# Lower Hastings Ranch Association (LHRA)

# Why are we appealing?

① SITE SECTION 1 - 605 RIM RD  
1" = 30'-0"

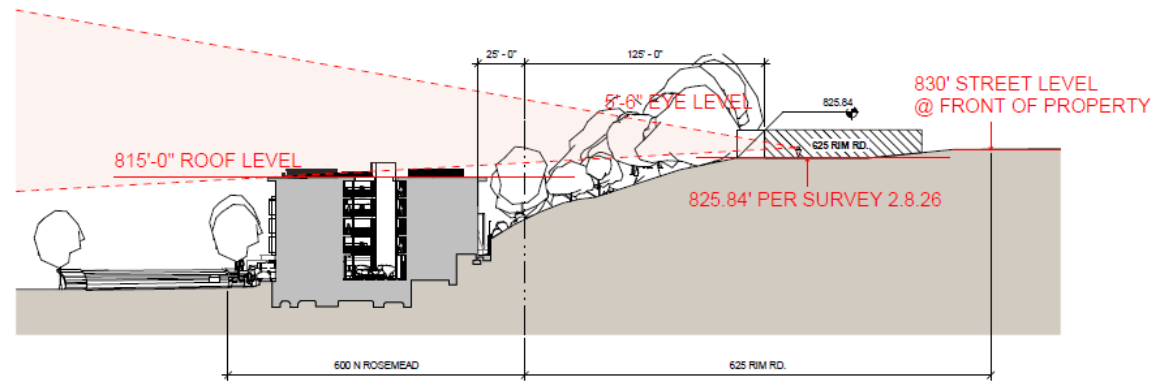
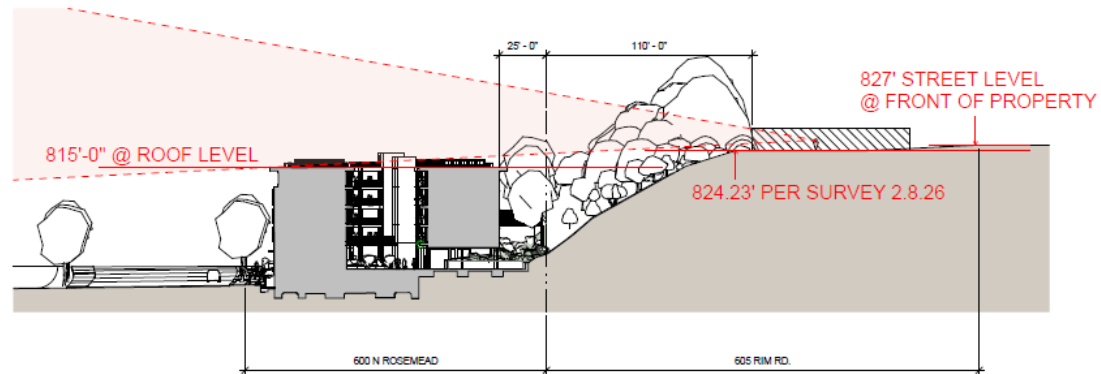
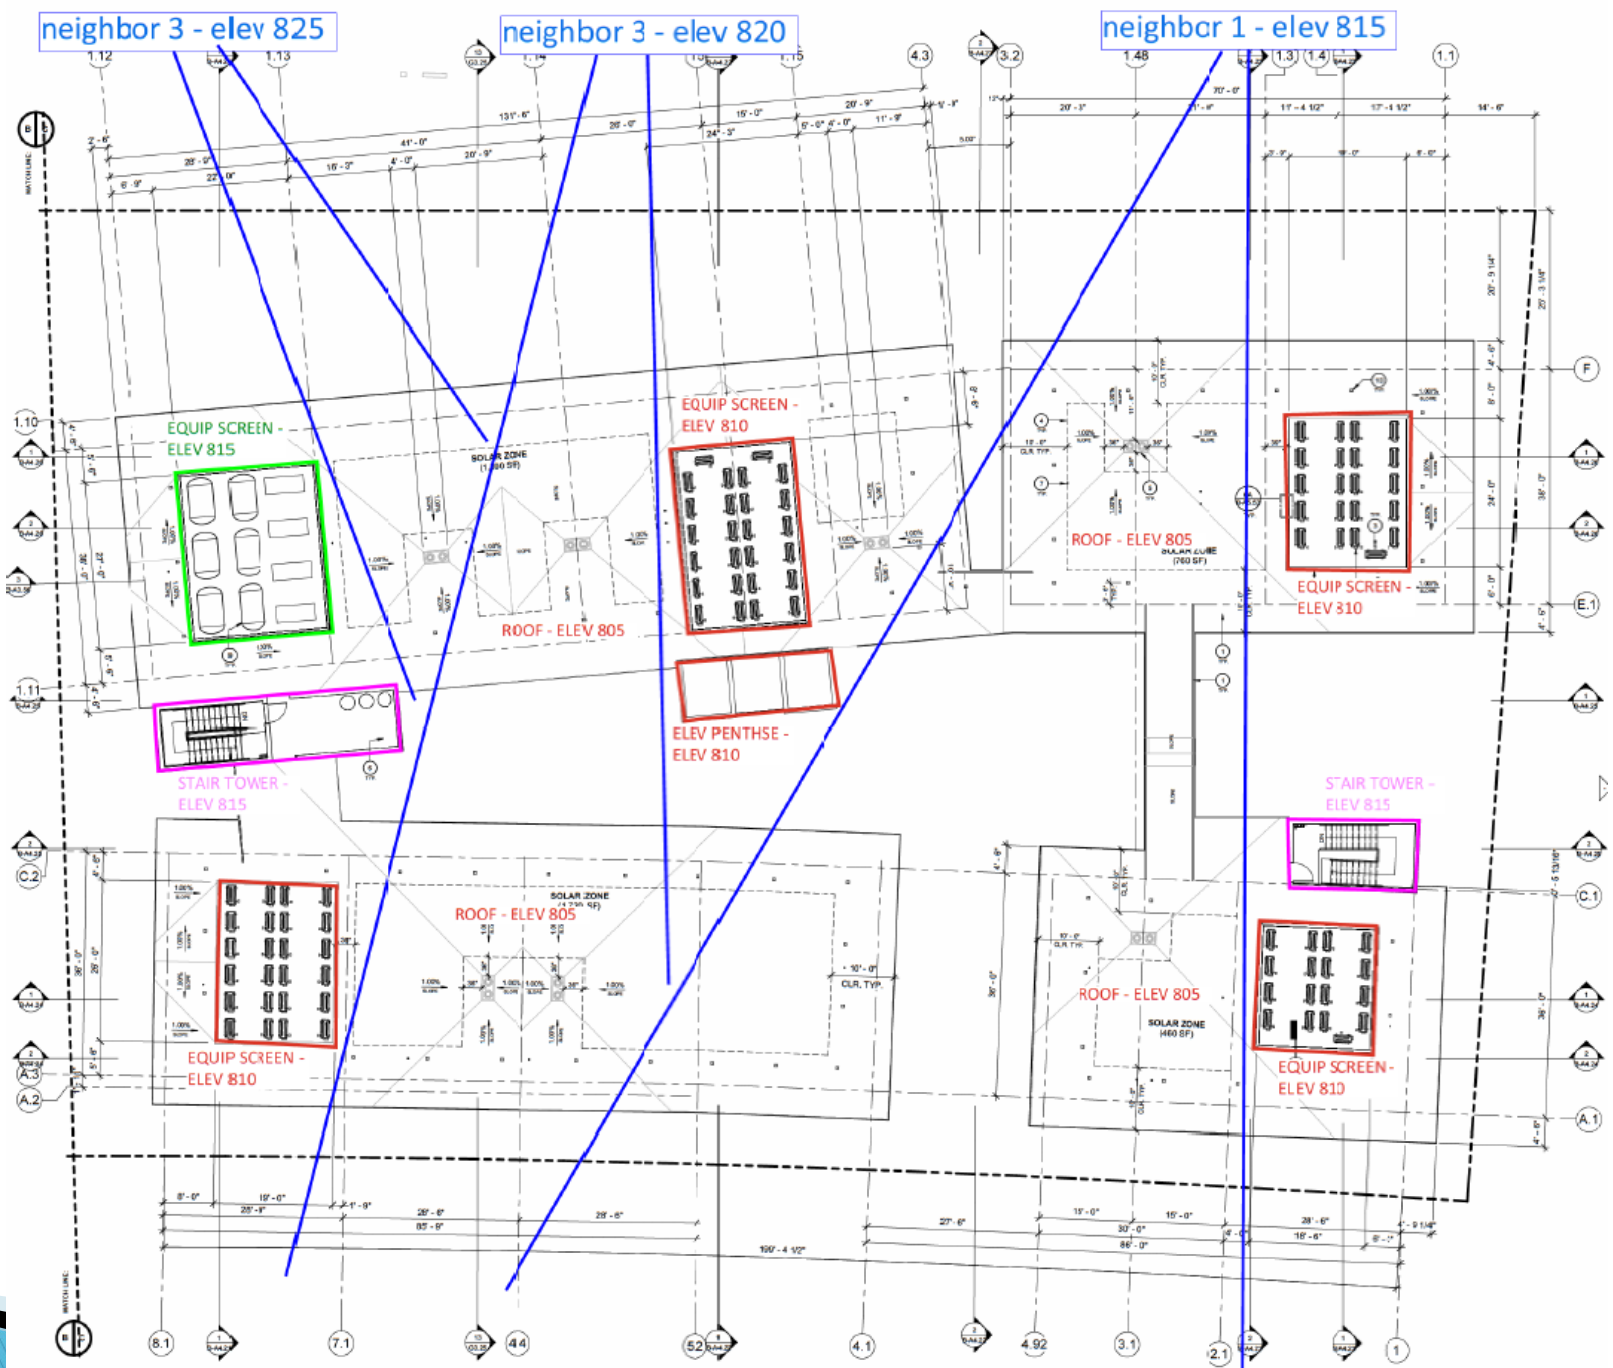
- ▶ Loss of view and privacy
  - Municipal Code protects views
  - Plans do not show sightlines accurately
  - Rooftop at 68 feet plus 12 feet of mechanical equipment, structures, fall protection
  - At same altitude as neighbors' backyards
  - Hillsides will have no view but building mass
